NACRA Sailing

Dear Nacra 15 and Nacra F16 customer,

Productive update Nacra 15 & Nacra F16 mast base to mast connection

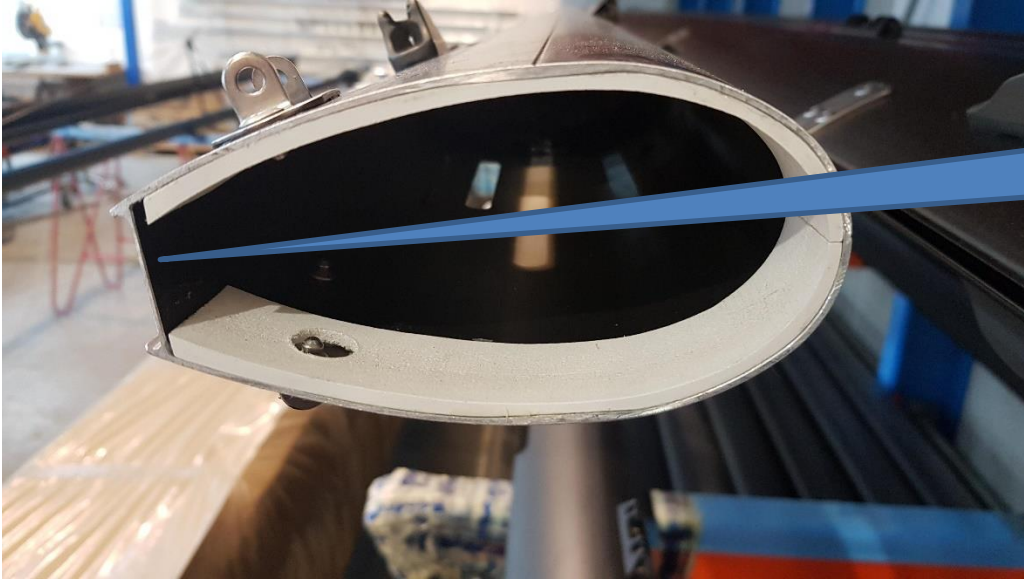
- Too much play between mast foot and mast profile.
- In some cases the mast base was able to penetrate into the mast profile.

Pictures below are from a mast that had too much play and was damaged.

Please disassemble your mast base from your mast

- The mast base can be disassembled by undoing the diamond tension bolt, after the mast is taken down from the boat.
- Check if the standard installed strips are still properly glued inside the mast (see picture below)
- Instal a new 3mm X 30mm X 18mm strip (see instructions below)

Mast as original
supplied

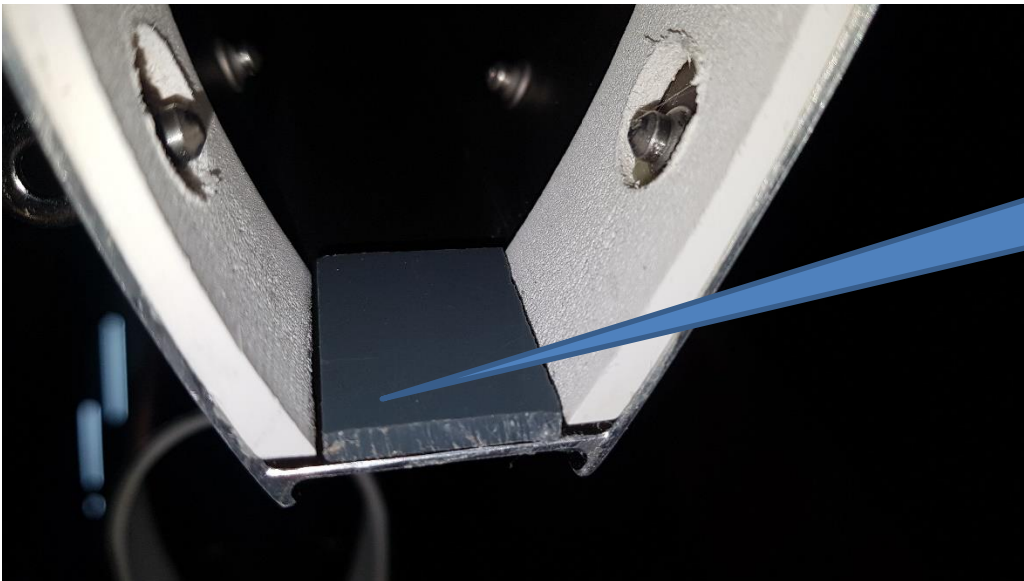
The above picture shows the original strips glued inside the mast without the new mandatory strip. Please check if the original strips are still properly glued.

New added
strip to stop
fore and aft
movement

Please glue in a strip as shown in the picture above, with an epoxy base glue. Only use a strip made from a composite material with a measurement of 20x30x3mm. needed
